工程指示編號：EI / 6433 / 23

修改版次：**B**

工程名稱：將軍澳日出康城 11

工程項目：幕牆 室內白色鋁板 (T1,T3 B 座 D 單位) 地盤用 放行

美特鋁質有限公司 MIDI Aluminium Fabricator Ltd.		工程號 J858	類別	物料號 -
修改	採用工廠	地盤 廣城11期	制圖 W. E. X	2022-12-02
日期	材料顏色 PVF2 (白色)	圖紙名稱 鋁折件	復核 -	圖號 CL-04
		材料 3.0mm 鋁板	批准 -	數量
				單件重量 - (KG)

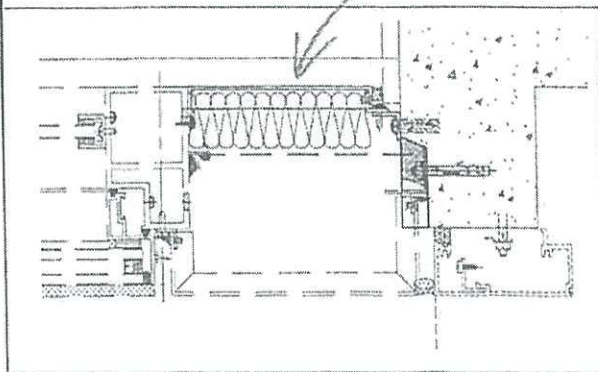
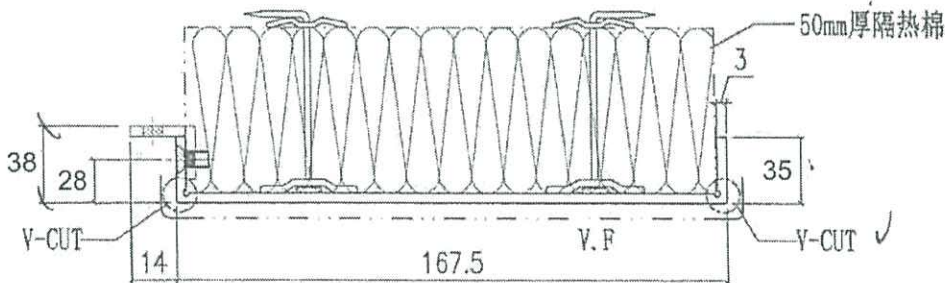
**B 版: (白色鋁板 167.5mm 鋁板)**

1. 按照 20/7/2023 會議放行，白色鋁板向內加 15mm。附 Email
2. 優先做 T1 12,15,16 /F 和 T3 12,15,16 /F 合共 6 件，優先出貨供樣板層完成(急)。
3. 分座包扎。
4. 大貨放行
5. 此單已代替 EI5644 生產，EI5644 不用生產
6. 兩邊有 V-Cut

美特鋁質有限公司 MIDI Aluminium Fabricator Ltd.			工程號	J858	類別		物料號	-		
			地盤	康城11期	制圖	W. E. X	2022-12-02	圖號	N00814-01	
修改日期		採用工廠	✓ 地盤	✓	圖紙名稱	鋁角加工圖	復核	-	數量	-
		材料顏色	絡化		材料	N00814	批准	-	單件重量	- (KG)

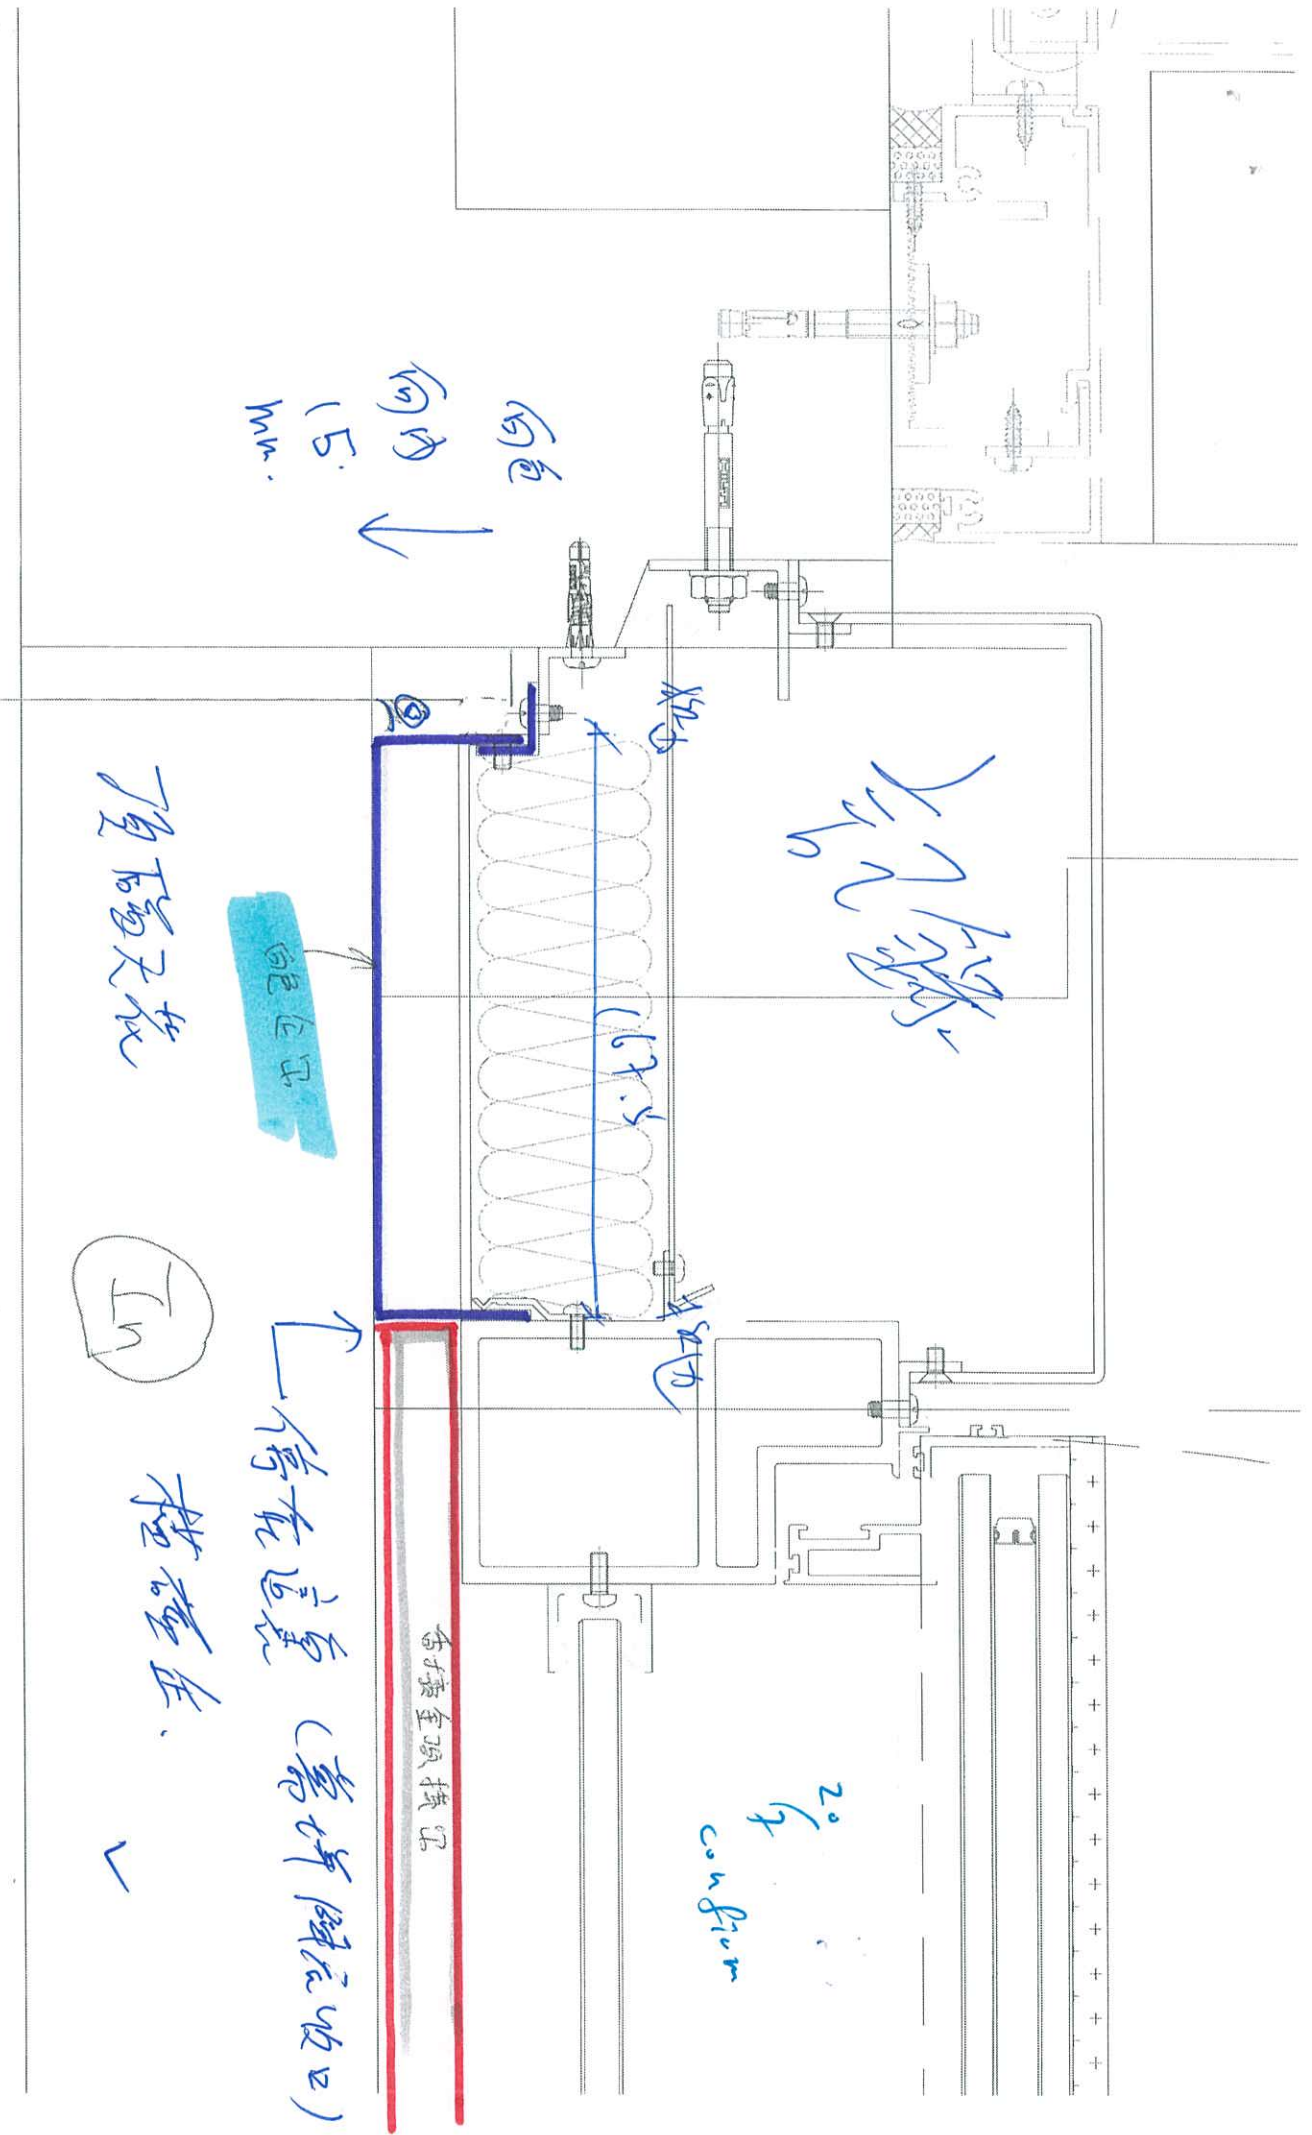
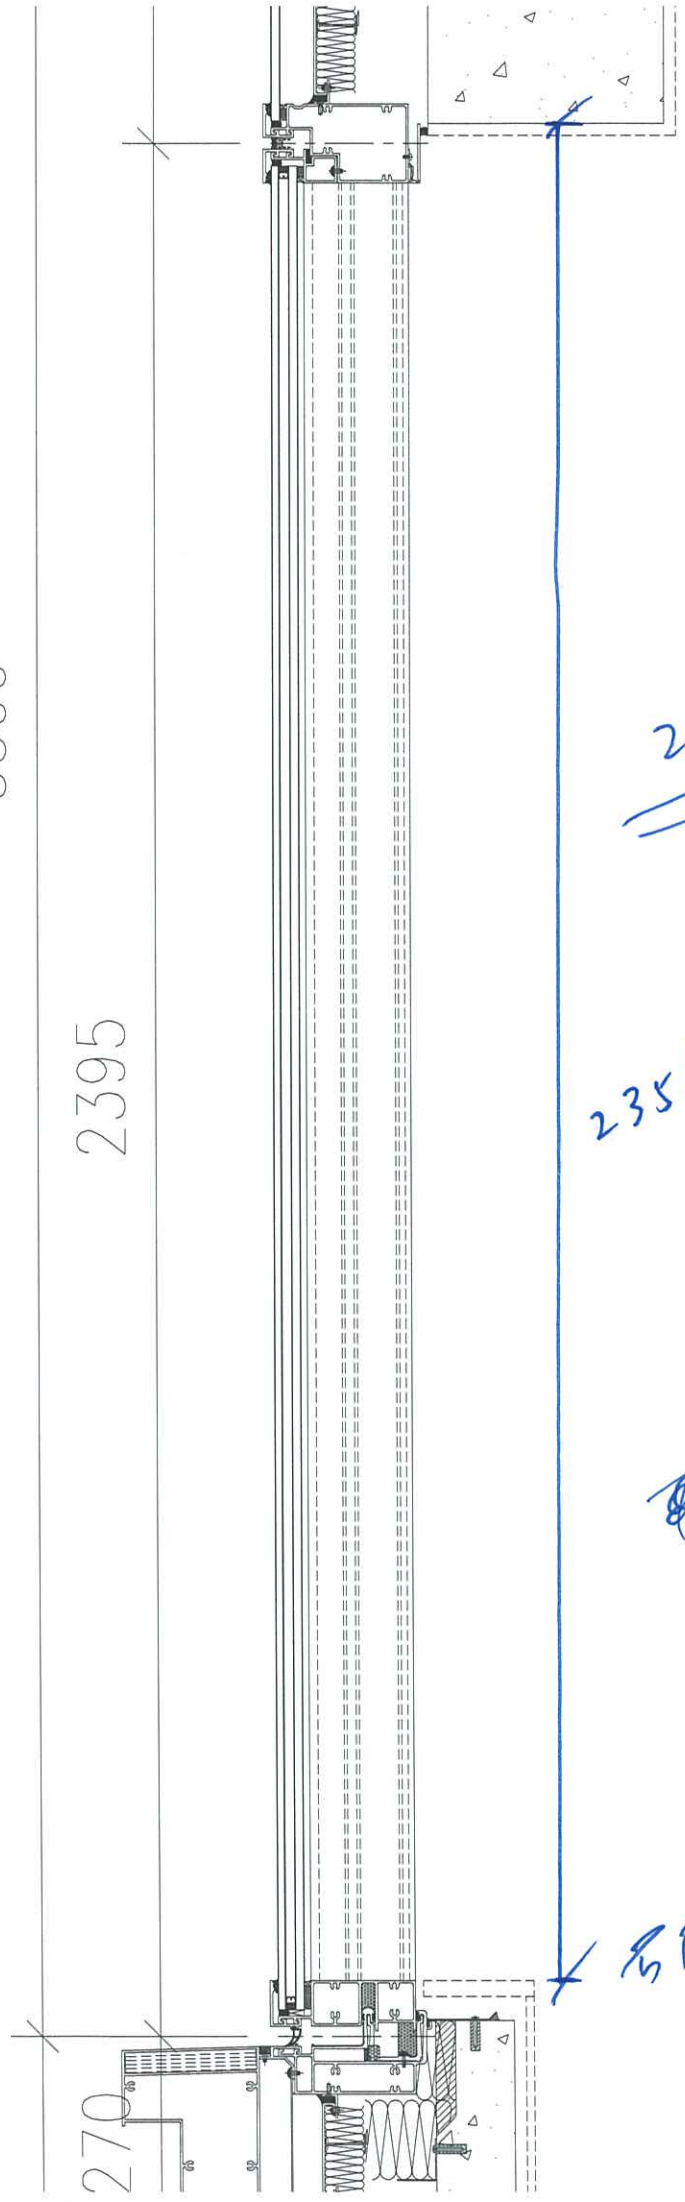
此室內白色鋁板頂碰天花 , (幕牆陣底收口)橫碰企。見附件

附件為T1, T3 B座D單位的室內白色鋁板。  
因應業主要求, 此白色鋁板需要追齊頂橫料收口(香檳金)。  
此白色鋁板將深度加15mm,  
請查看並確認。
